HURRICANE CITY UTAH

Hurricane Planning Commission Meeting Agenda

March 14, 2024
6:00 PM

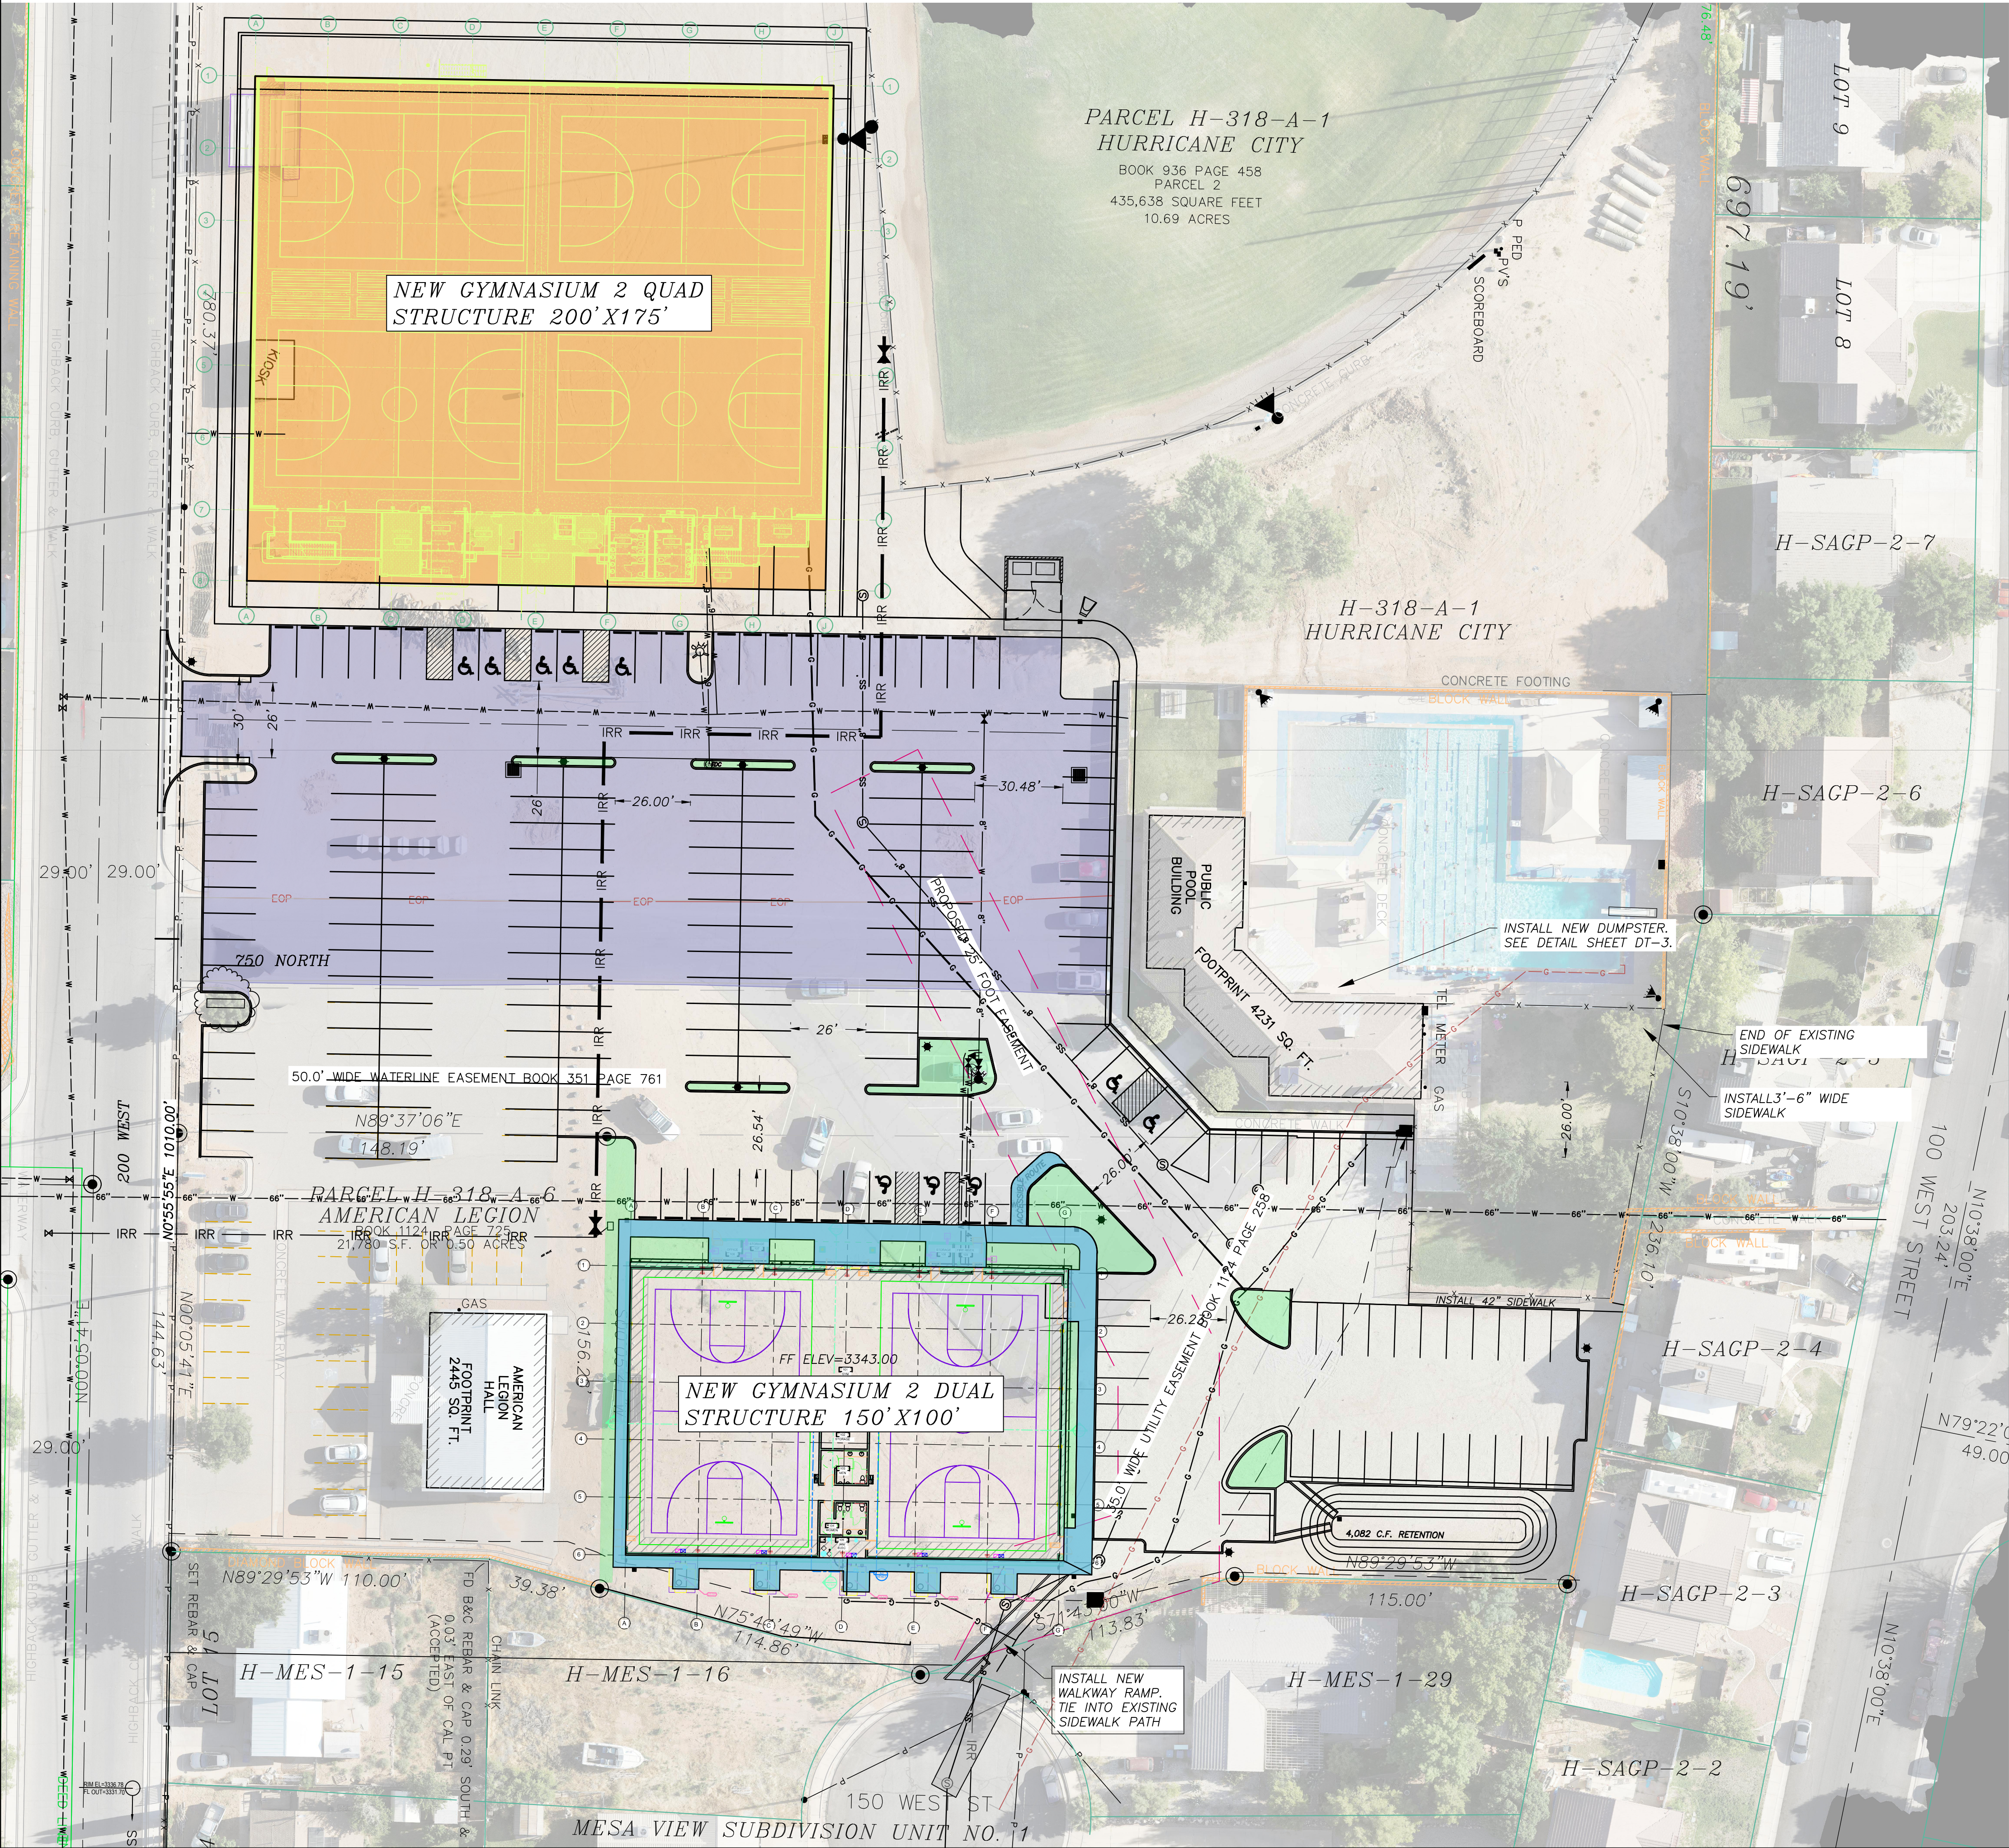
4. *Pedestrian circulation throughout the site should be considered in the design, there will presumably be a large amount of pedestrian cross traffic between the different uses on this property as well as to the neighboring streets and neighborhoods.*

5. *Building plans and elevations have been provided, although not required at this stage. The building height is 34' tall which meets city code.*

6. *A preliminary site plan is not intended to permit actual development of property pursuant to such a plan but shall be prepared merely to represent how the property could be developed. Submittal, review, and approval of an application for a preliminary site plan shall not create any vested rights to development. (Hurricane City Code 10-7-10 (D)(2)(b))*

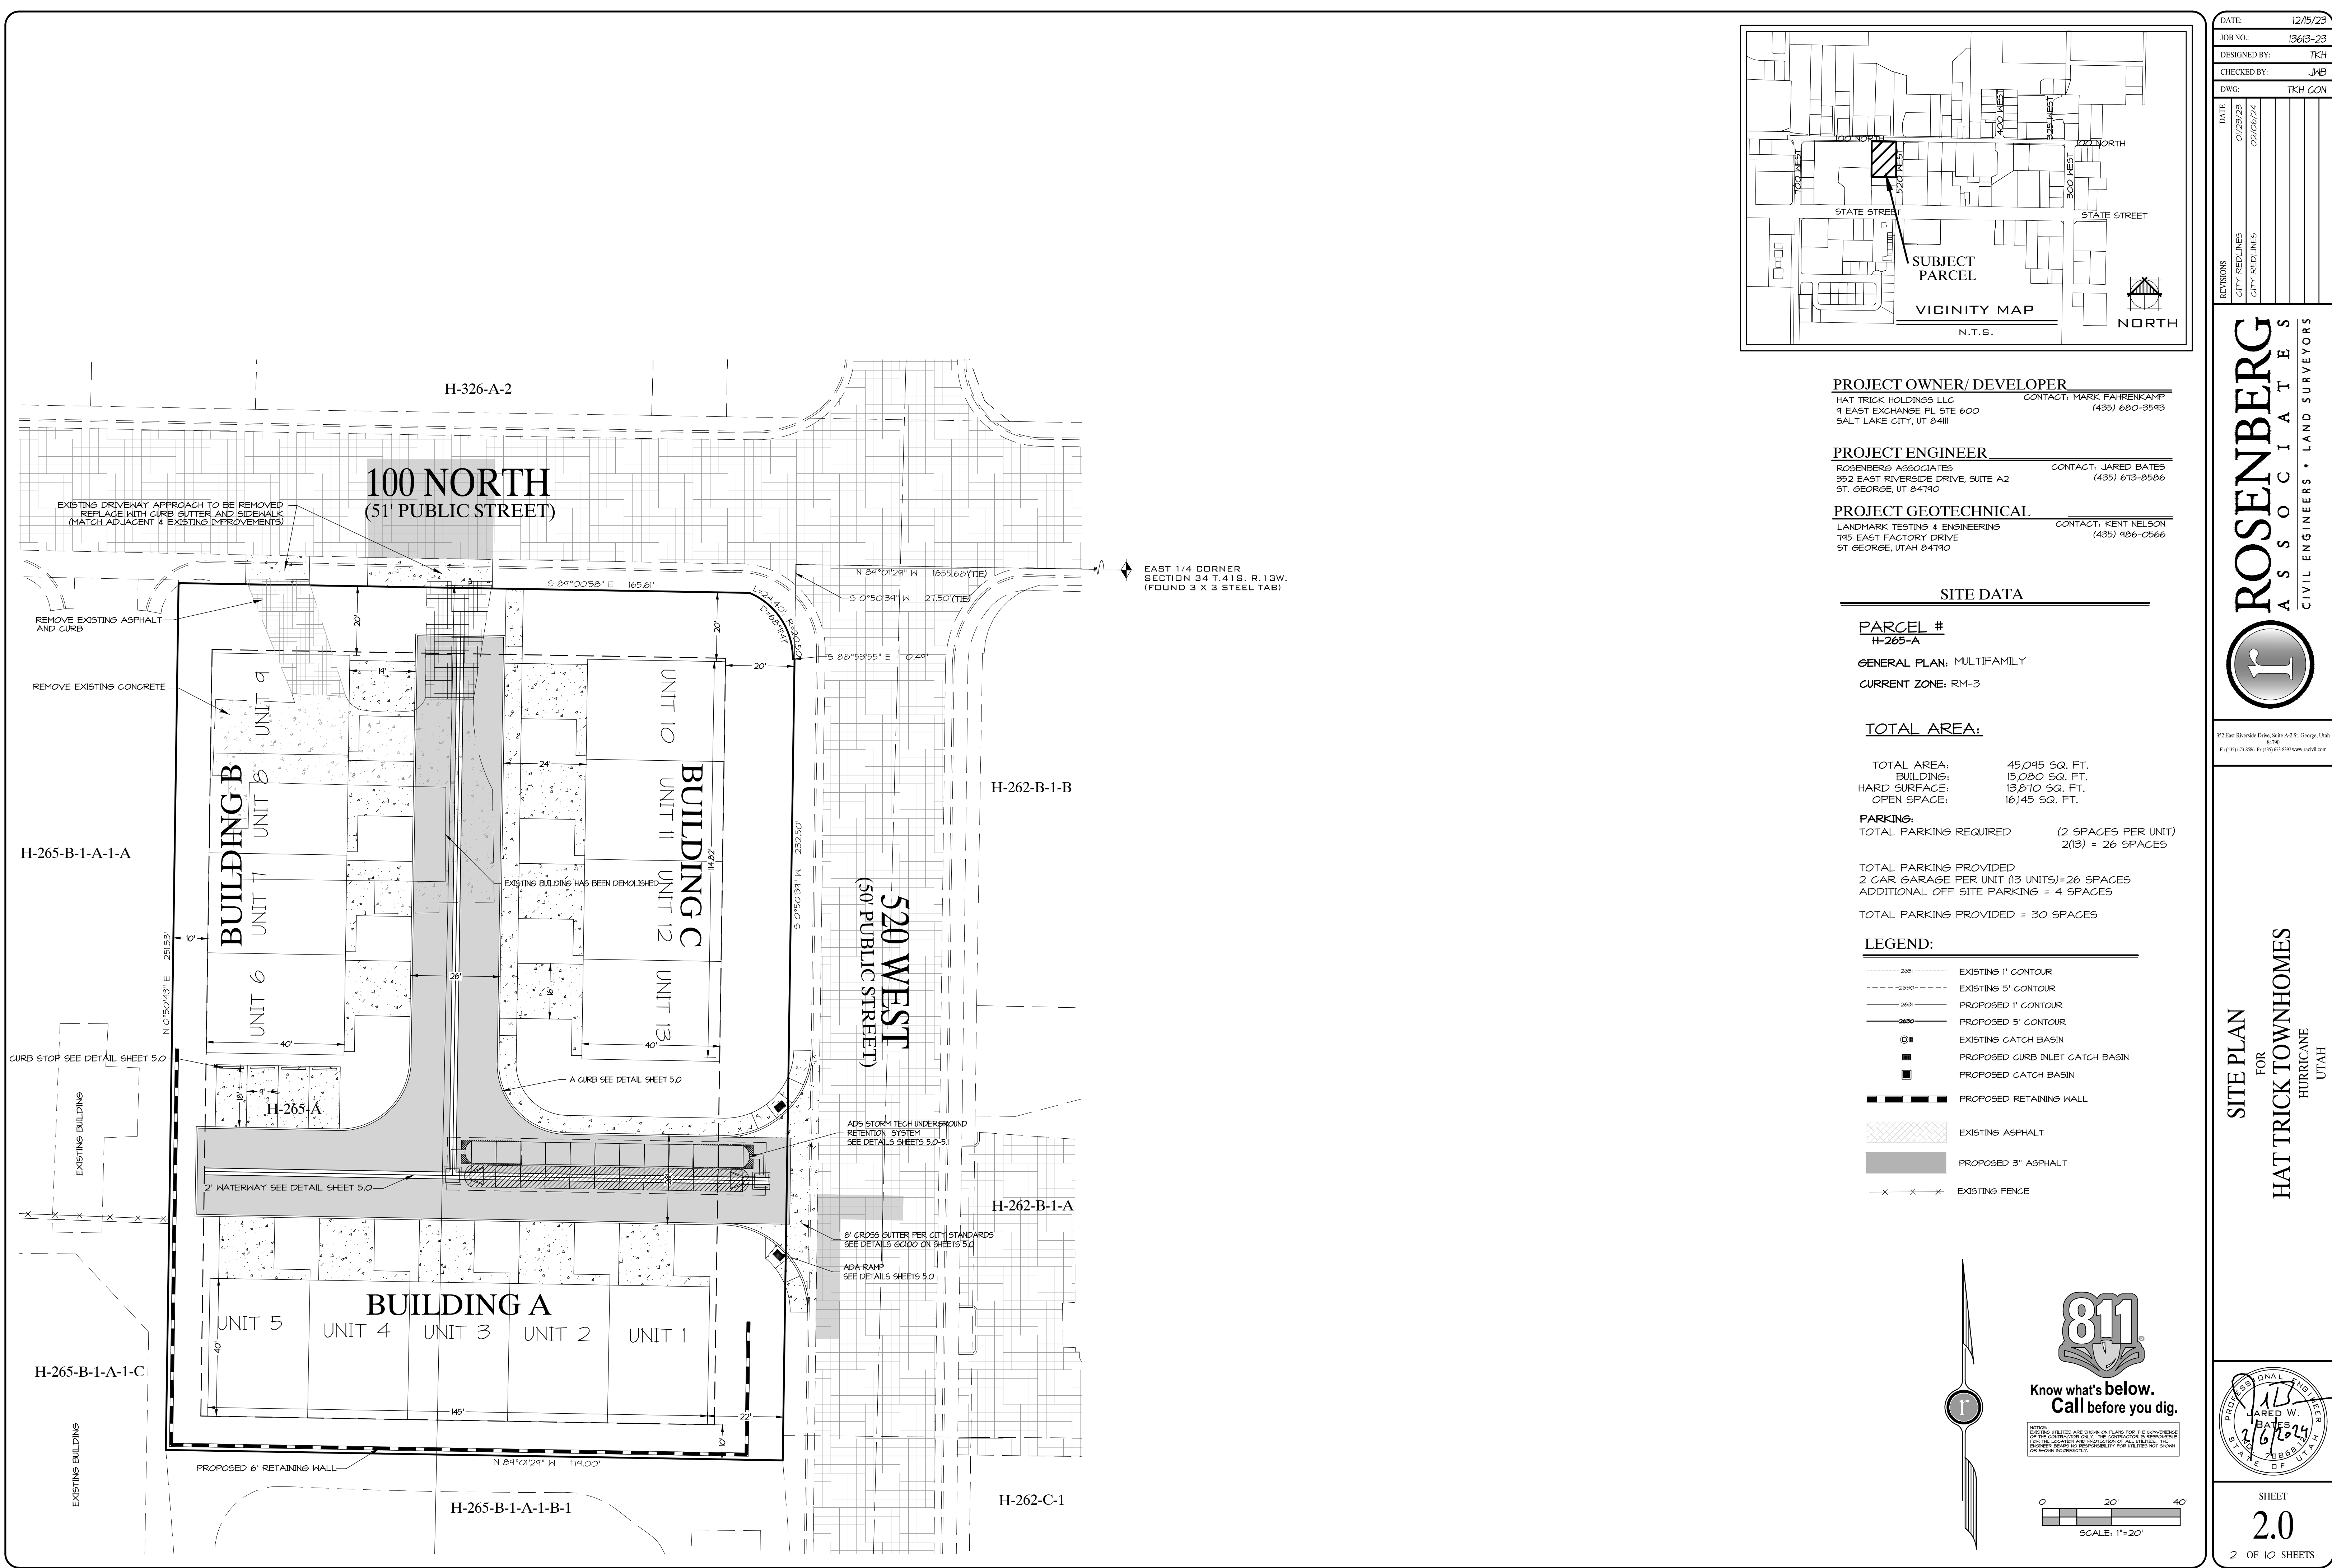
9. Building elevations have been provided. All units will be under 35' tall.

Recommendation: Staff recommends the Planning Commission review this application based on standards within Hurricane City Code. Staff recommends continuing this application until a compliant landscaping plan is provided.
